**Detailed Site Plan**  
**Departure from Design Standards**  
**Alternative Compliance**  
**PMG Brooks Drive**

**DSP-20016**  
**DDS-670**  
**AC-20009**

SUBJECT: Detailed Site Plan DSP-20016  
Departure from Design Standards DDS-670  
Alternative Compliance AC-20009  
PMG Brooks Drive

Figure 1: Site Development Plan

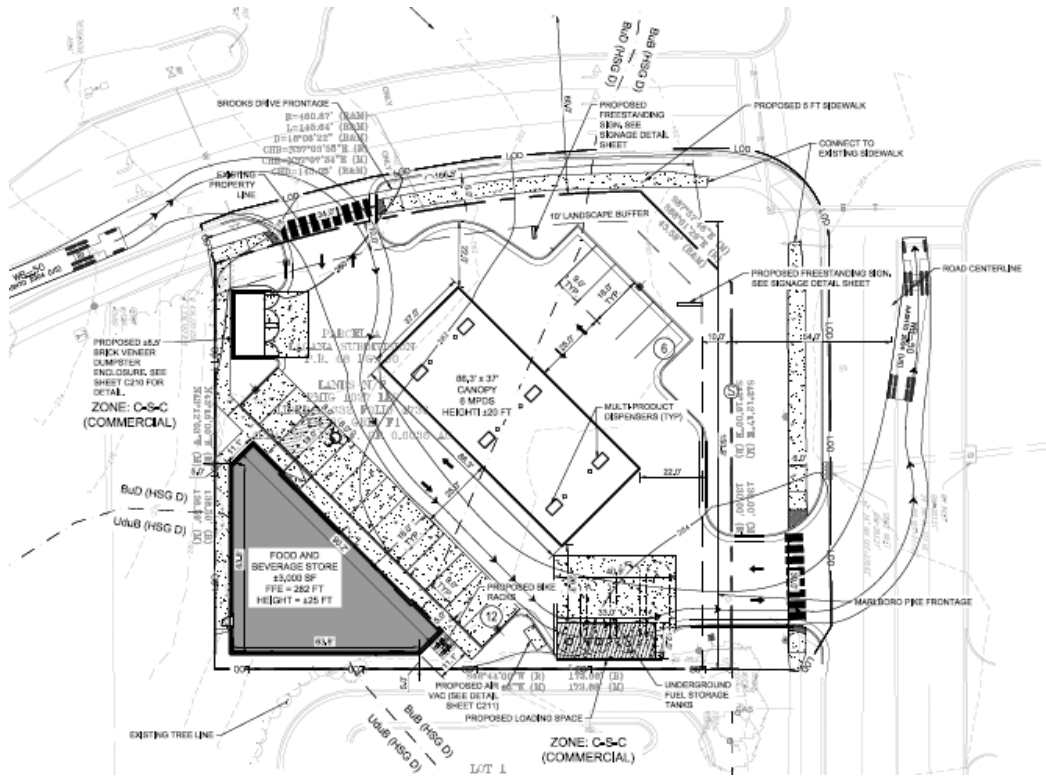
As shown on the plan, a five-foot-wide sidewalk provides a complete pedestrian connection between the proposed food and beverage store building and Brooks Drive. However, in reviewing this requirement relative to the site design guidelines contained in Section 27-274 of the Zoning Ordinance, as cross-referenced in Section 27-283 of the Zoning Ordinance, staff recommends that a clearly defined pedestrian connection also be provided between the building and Marlboro Pike. It is important to have one in this area as there is a bus stop along Marlboro Pike in front of the adjacent property, so there will be pedestrian traffic along this roadway in need of safe access into the site and to the building. A condition requiring such a connection to serve pedestrian traffic is included in the Recommendation section.

- b. **Transportation Planning and Trails**—In a memorandum dated October 21, 2020 (Smith and Hancock to Bossi), the Transportation Planning Section noted that the proposed parking and vehicular circulation facilities are acceptable. The reduction of access points to Brooks Drive and Marlboro Pike and relocation of remaining access drives away from the intersection will help avoid traffic conflicts. A five-foot-wide sidewalk is included along Brooks Drive, with connection between the proposed building and Brooks Drive provided. A six-foot-wide sidewalk is provided along Marlboro Pike, in accordance with the recommendations of the 2009 *Approved Marlboro Pike Sector Plan and Sectional Map Amendment*. Staff has determined that a pedestrian connection between the food and beverage store and Marlboro Pike is appropriate and necessary to demonstrate acceptable pedestrian circulation has been provided, especially because there is a bus stop along Marlboro Pike in the vicinity of the site. A condition has been included in the Recommendation section for this pedestrian connection to be provided.

1. Prior to certification, the detailed site plan shall be revised, or additional information shall be provided, as follows:
    - a. Provide a pedestrian connection, in the form of sidewalks, pavement markings, or other facility, from Marlboro Pike to the entrance of the food and beverage store.

Figure 2: Food and Beverage Store Elevations

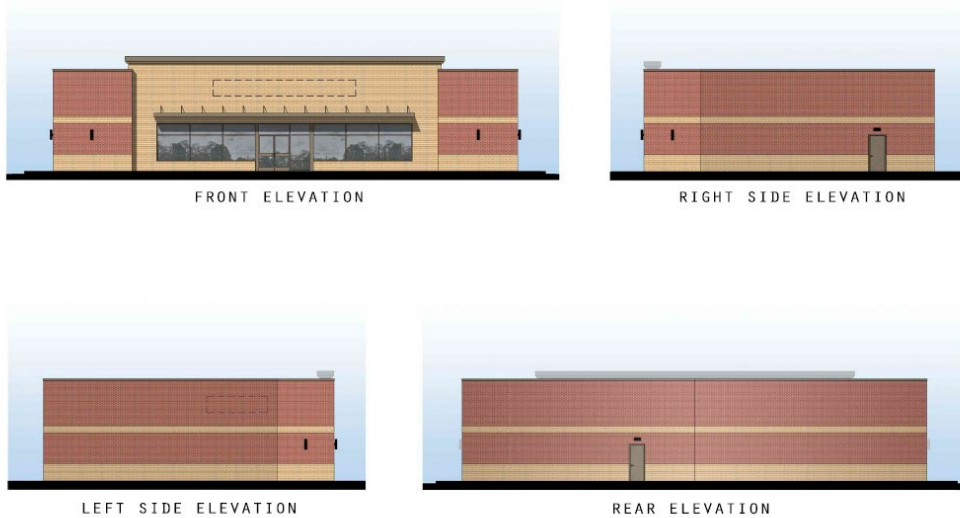
Architectural elevations of each façade of the proposed building and gas station canopy were provided. The images show structures that are compatible with existing development in the surrounding area. Complete details regarding the building's architecture, such as a schedule of exterior finishes, was not provided. A condition has been included in the Recommendation section to require the DSP to be revised to include this information.

- b. Provide dimensional data and labels of features and materials on all architectural elevations for the food and beverage store.
    - c. Revise the plan and signage table to include gas station canopy mounted signage data and demonstrate canopy mounted signage conforms with Section 27-613(c) of the Prince George's County Zoning Ordinance.

Figure 4: Signage Examples

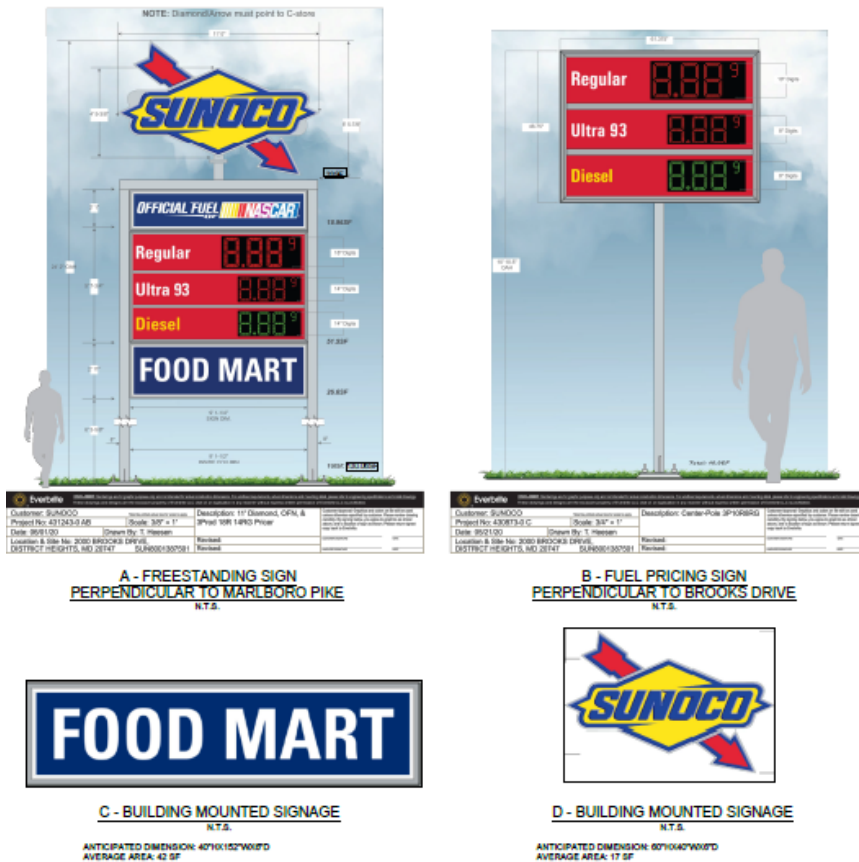
A comprehensive signage program is provided that includes freestanding, canopy-mounted, and building-mounted signs for the proposed gas station and food and beverage store. Building-mounted signage is designed in conformance with Section 27-613 of the Zoning Ordinance. Canopy-mounted signage area is not provided on the DSP and appears greater than permissible by Section 27-613(c). Details are provided for two freestanding signs, one with fuel pricing only, and a second larger sign with fuel pricing and business identity and advertising. Locations for both freestanding signs are shown adjacent to the intersection of Brooks Drive and Marlboro Pike. The second, smaller sign with fuel pricing only is permissible per Section 27-594(a) of the Zoning Ordinance, which requires a price sign at each entrance to the station. It is also in conformance with the requirements of Section 27-614(c)(6) of the Zoning Ordinance, relative to allowed area. A condition has been included in the Recommendation section for the signage plan to be revised to conform with Section 27-613.

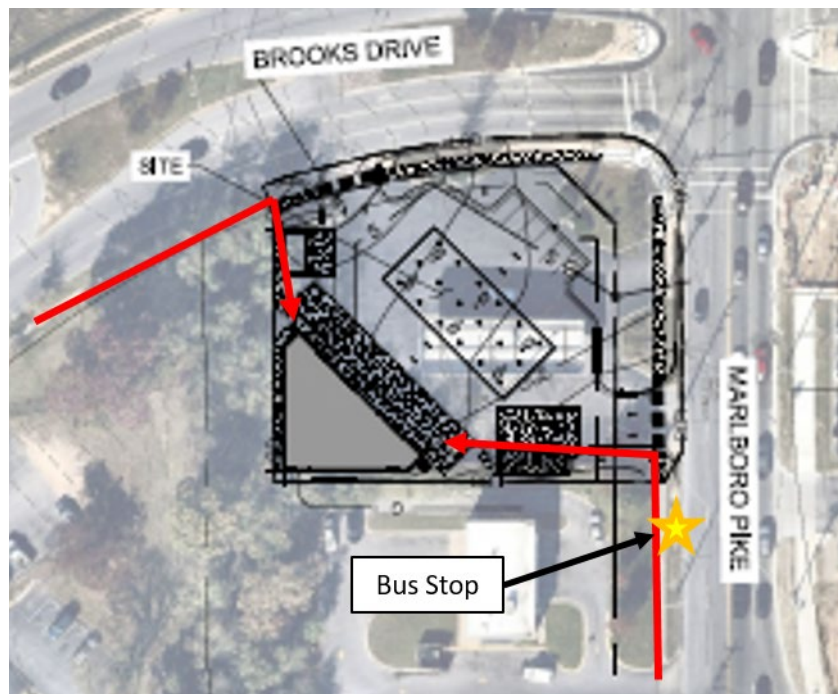
**Comment:** Staff find that the vehicular and pedestrian circulation depicted in the submitted site plan does not reflect the design guidelines of the Zoning Ordinance, pursuant to Section 27-583 and 27-274, and 27-538. Staff recommend an additional pedestrian connection, in the form of a sidewalk, pavement markings, or other improvements, from Marlboro Pike to the building entrance.

1. Prior to certification of the detailed site plan, the applicant, or the applicant's heirs, successors, and/or assigns shall revise the plans to provide:
